Subject: Arroyo Vista Median Swale

INSPIRATION SUBDIVISION
PROPOSED BASINS MAP

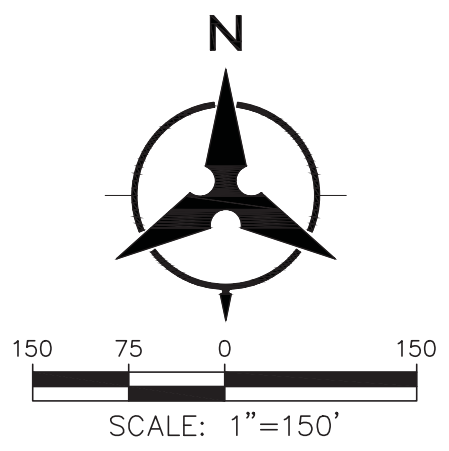
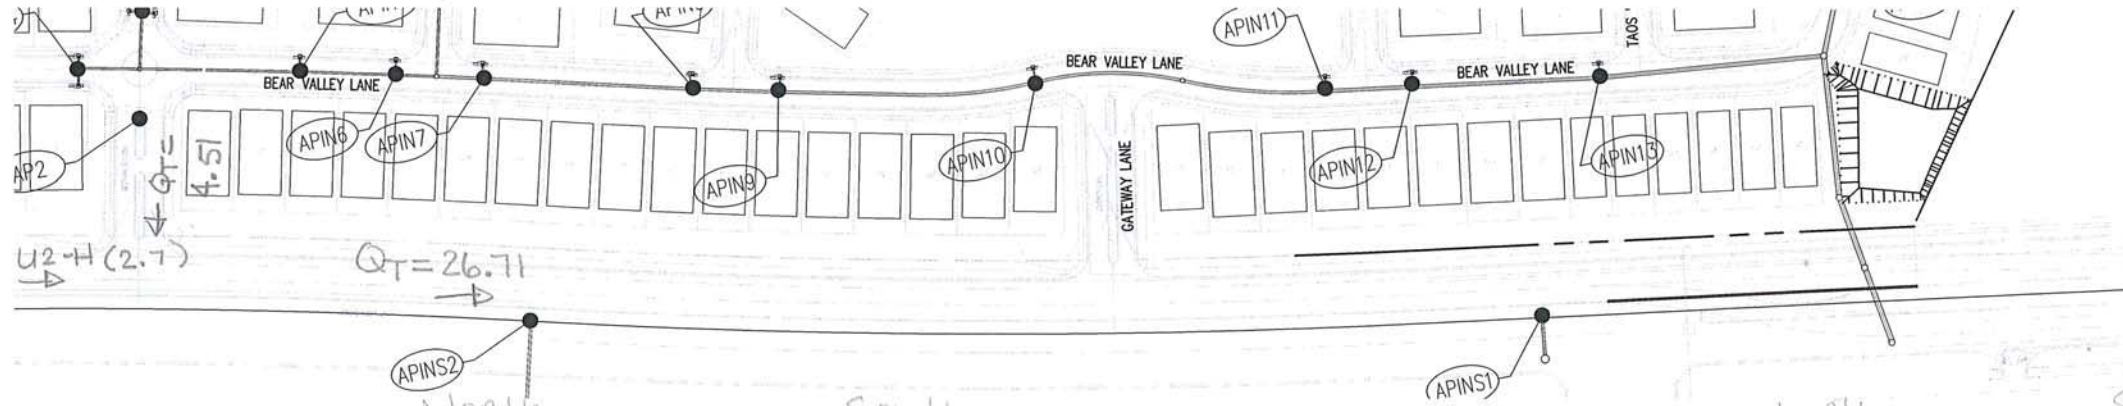
Enclosed is the Inlet Schematic 7 from the report marked up with the revised/added flows. Also enclosed is the Proposed Basin Map show the portion of OS-2 and interm Basin AR South as well as the basins boxed which contribute to the total flow. Inlet analysis ins also included which show the ultimate\future as well as the interim condition.

AR-South (interim basin)

AR-SOUTH	2.11	0.00%	0.00%	100%	0.00%	1.6	2.11		
----------	------	-------	-------	------	-------	-----	------	--	--

HEC-HMS (v4.2) Schematic:

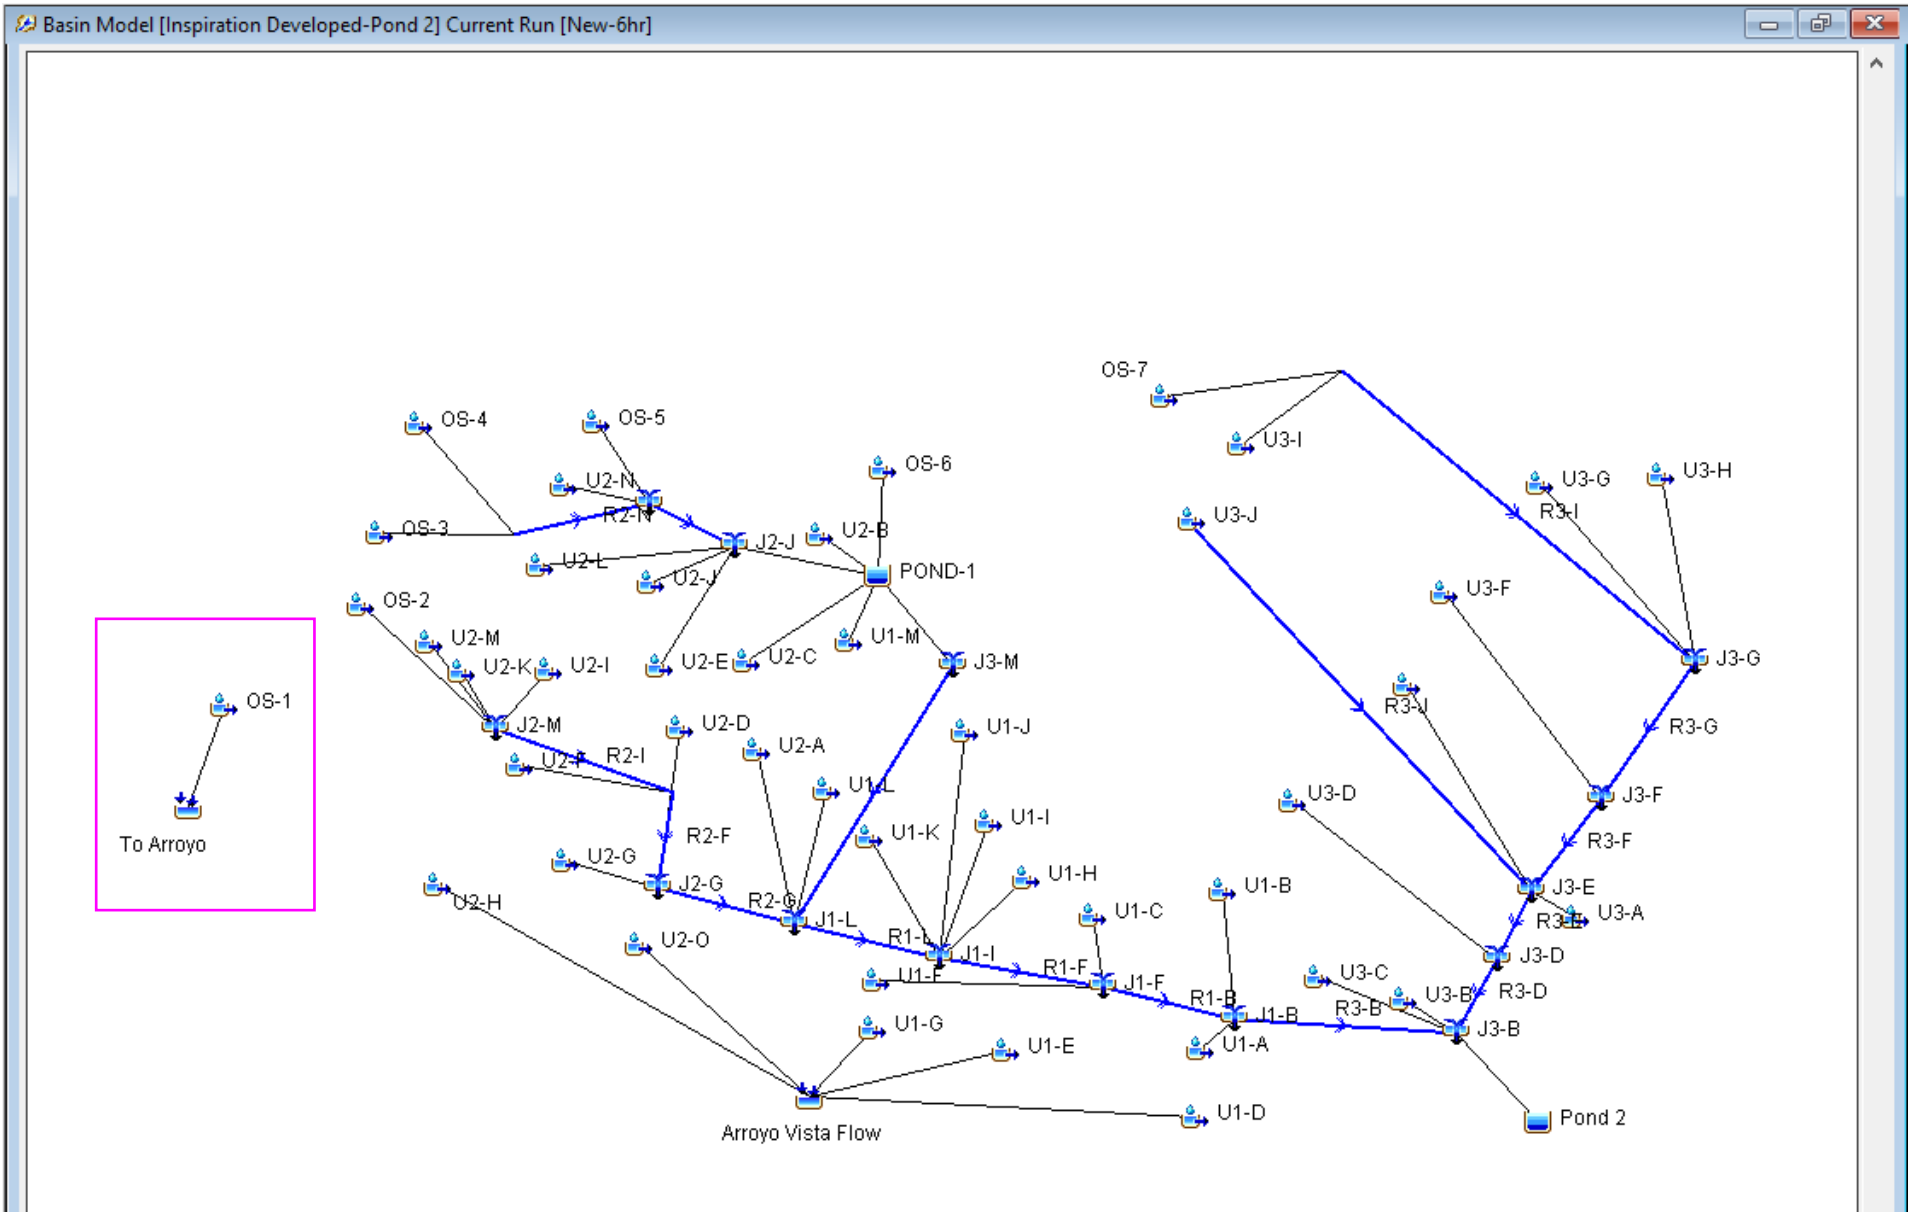
To speak to OS-1, Curtis was correct in that the written portion of the report does not speak to OS-1's discharge location, however, in the HEC-HMS model output which is located in the report Appendix D it does show that OS-1 was analyzed to discharge to the arroyo to the south of Arroyo Vista. I have included this page for reference. In addition, we did double checked the model to confirm this.
